Staff Report to the Planning Commission

Application Number: **03-0065**

Project Description: Proposal to construct 43 attached townhouses, a common area with parking, landscaping, and access roadways, and the creation **of** a separate open space parcel comprising the remainder of the subject property to be rezoned from the RM-3 (Multi-family Residential) zone district to the PR (Parks, Recreation & Open Space) zone district.

COLORIZED SITE PLAN AND PROJECT DATA
CABRILLO COMMONS

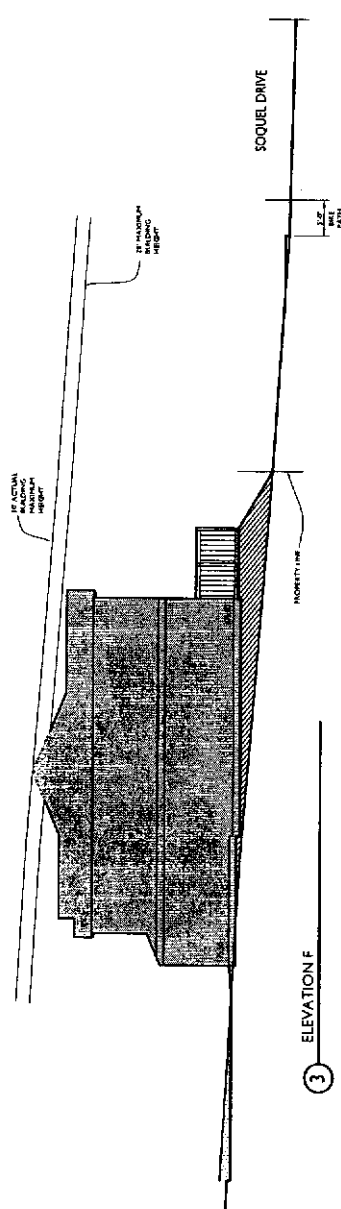
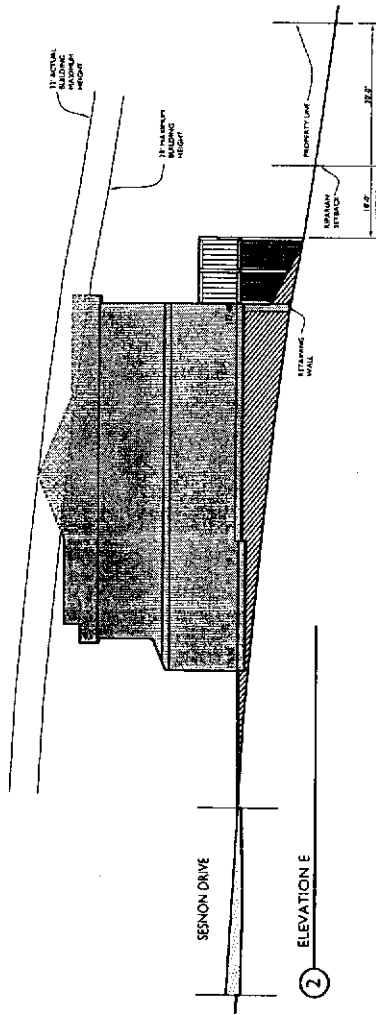
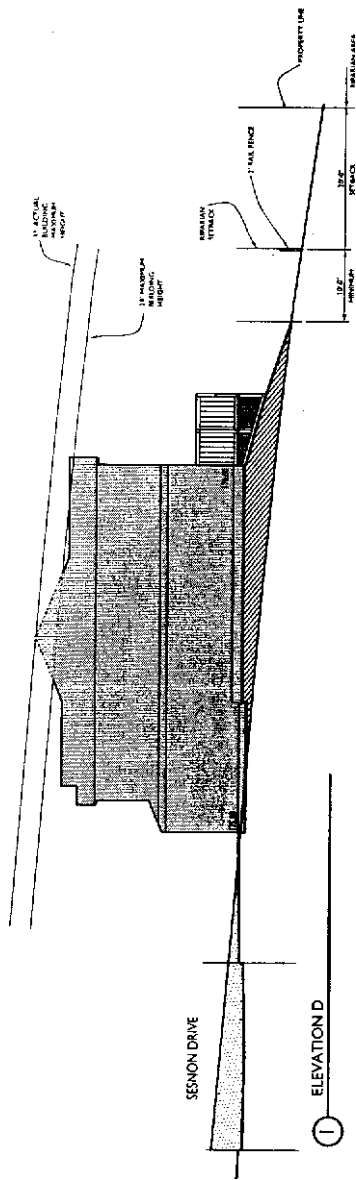
1. A fill slope is shown in plan view along the east side of the development (behind units 12-25), but x-sections A, B & C shown on sheet 6 do not reflect a fill slope. If the foundations are stepped as the x-sections indicate, then the fill slope should not be needed. Revise plans so that the x-sections and plan view match.

Example 2) T&T sheet 7, section 1 shows grading up to the property line (which actually must be setback 3' from the property line. Iflands plans show the toe of the fill setback from the property line as well as a swale.

Example 3) T&T sheet 7, section 3 shows a 3:1 slope behind the building, but Iflands plans show a 2:1 slope. The distances from the building to the riparian setback as well as the property line are also different. The elevations of the grading (fills) are also different

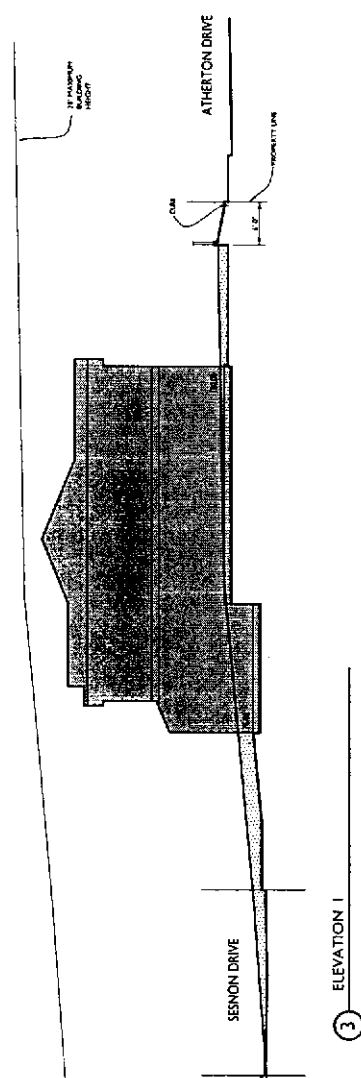
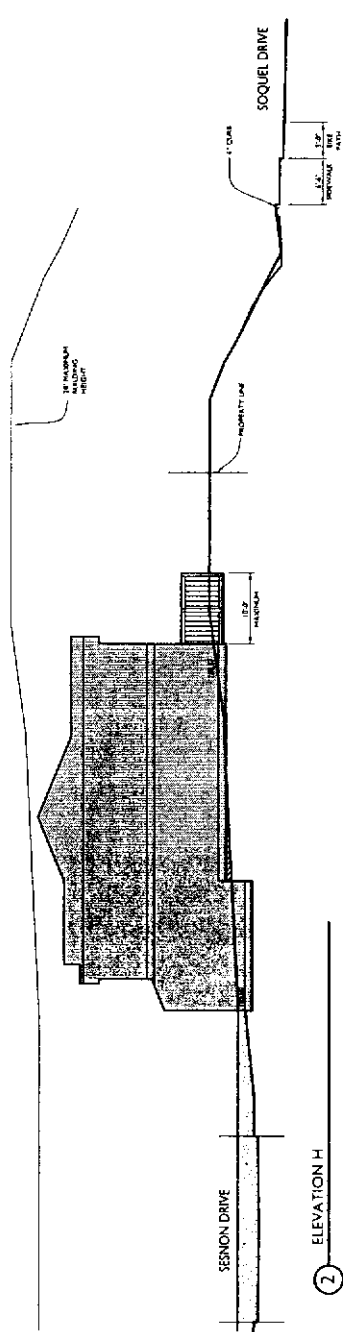
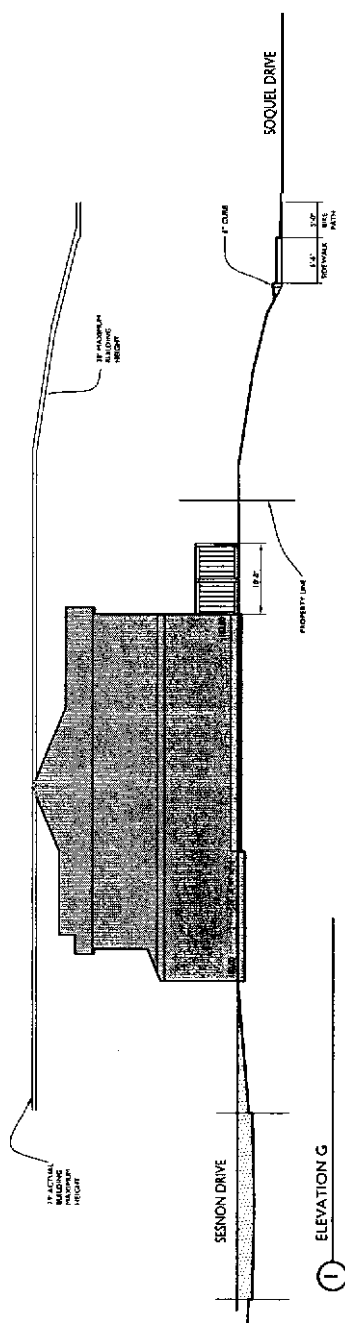
Example 1) Thatcher and Thompson (T&T) sheet 8, section 2 shows -19' from the edge

of the building to the riparian setback and 39' to the property line. Iflands sheet 5 shows 23' and 43' respectively.
